NOTICE OF A TYPE Ix DECISION ON A PROPOSAL IN YOUR NEIGHBORHOOD

CASE FILE NUMBER: LU 19-260377 HR – REMOVING DOORS IN HISTORIC DISTRICT

Site Address: 411 NW Flanders St

C-1

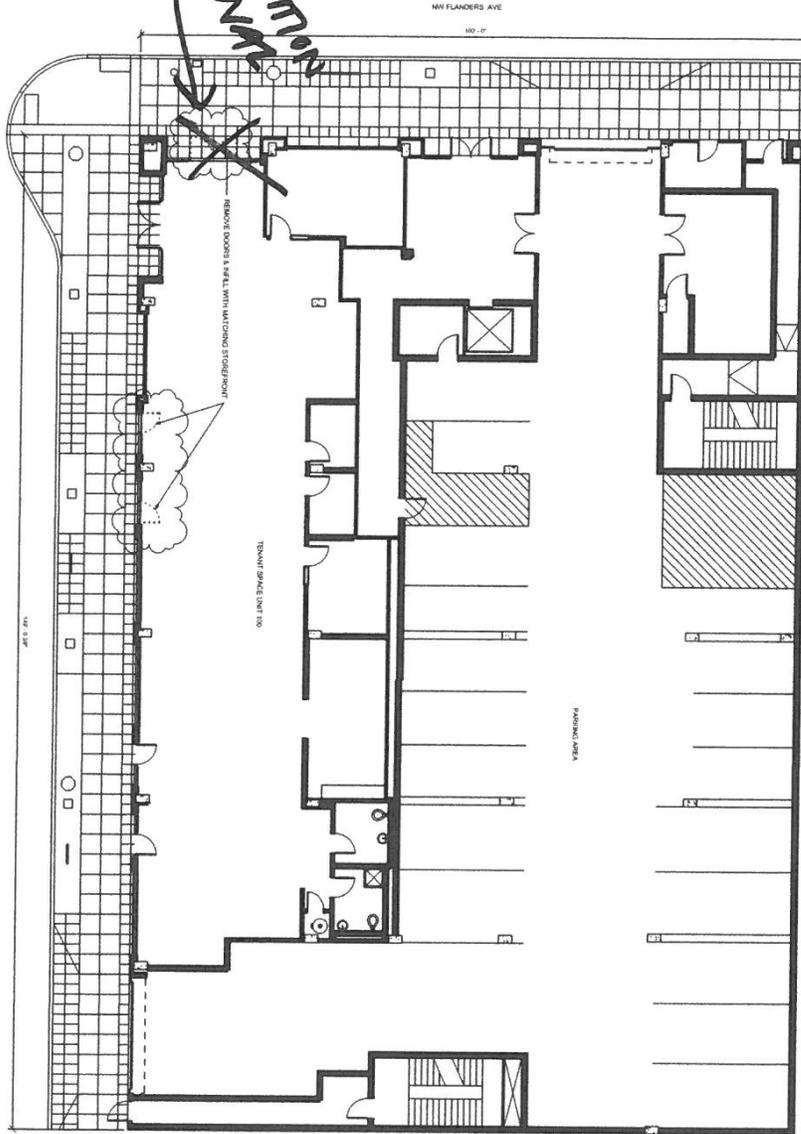
However, the proposal to remove the paired entry fronting NW Flanders would remove the sole entry from that street into the commercial space. It would result in a weaker pedestrian system, and is therefore not approvable. Condition of Approval C states that the paired entry doors at the corner shall remain in place.

The proposal to remove primary corner entry doors facing NW Flanders, and to replace them with storefront glazing would eliminate the only entrance facing this street, and would result in a weaker corner condition. Therefore, it does not meet Guideline C3 – Respect Architectural Integrity or Guideline C7 – Design Corners that Build Active Intersections.

Approval of replacing two single doors fronting NW Fourth Avenue with storefront glazing, per the approved site plans, Exhibits C-1 through C-3, signed and dated February 11, 2020, subject to the following conditions:

- C. All paired entry doors at the corner shall remain in place.
- D. No field changes allowed.
